TO: Mercedes-Benz Dealer Principals, General Managers, Sales Managers, Service Managers, Parts Managers	FROM: Anthony Washington, Senior Manager, Regulations and Certifications
Re: Launch Recall Campaign Notification Model Sprinter 907 Model Years 2021-2023 Replace Fuel Delivery Module	DATE: October, 2023

Campaign No. 2023090004 October, 2023

SUBJECT: **Model 907 Sprinter, Model Year 2021-2023**
Replace Fuel Delivery Module

D47.20-A027-03

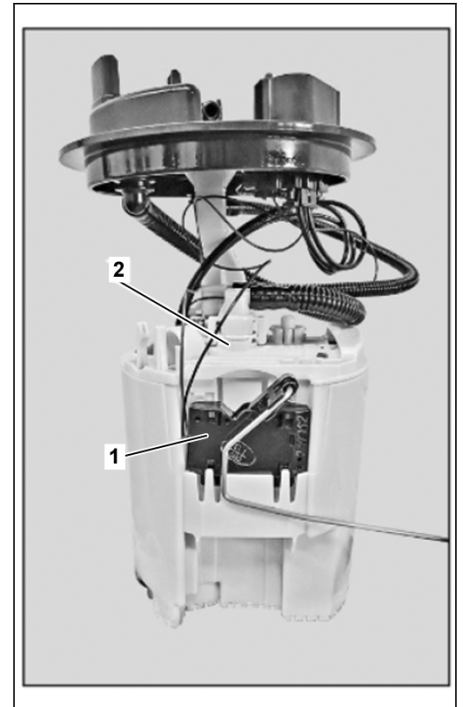
Mercedes-Benz AG, the manufacturer of Sprinter vans, has determined that on certain Sprinter (907 platform) vehicles the fuel pump impeller might not meet specifications in regards to material characteristics. As a consequence, the impeller might deform and come into contact with the fuel pump housing, leading to a mechanical resistance. In some instances, this could lead to a shutdown of the fuel pump. As a result, the vehicle could lose propulsion, which could increase the risk of a crash or injury.

As a precautionary measure, MBUSA will check the fuel delivery module on the affected vehicles and replace it, if necessary.

- 1 Fuel tank fill level sensor
- 2 Fuel feed module

SM47.20-D-0027-02SG	Modify fill level sensor of fuel delivery module (code: VS3KRAPUMP, acc. no.: 47 902 07)		
---------------------	--	--	--

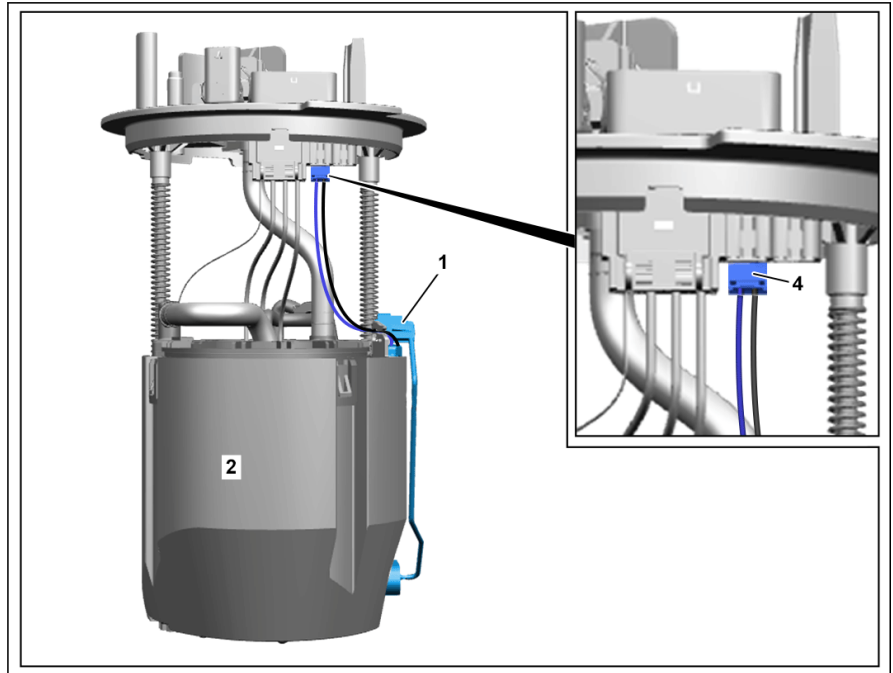
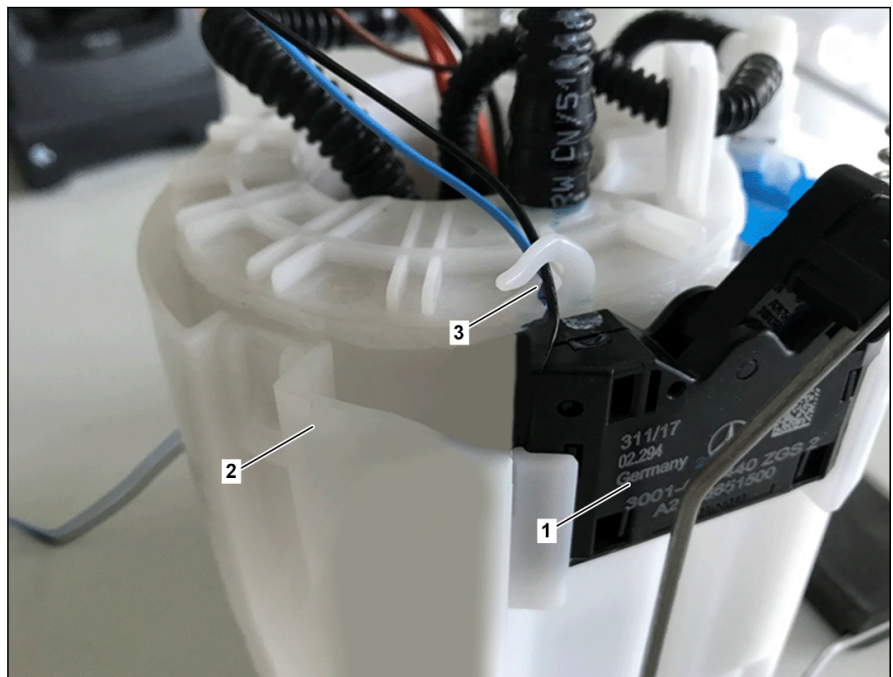
**Paragon may substitute for A907470550028 (without FILL LEVEL SENSOR)

Work instruction for modifying the fuel delivery module
without fill sensor are shown on the next page

- 1 Release and disconnect electrical connector(4).

- 2 Unclip electric lines from line routing (3).

- 3 Push fill level sensor (1) forwards in area of line routing (3) and then unclip upwards.

i Installation:
Check that the fill level sensor (1) is correctly locked.

- 4 Install in the reverse order.
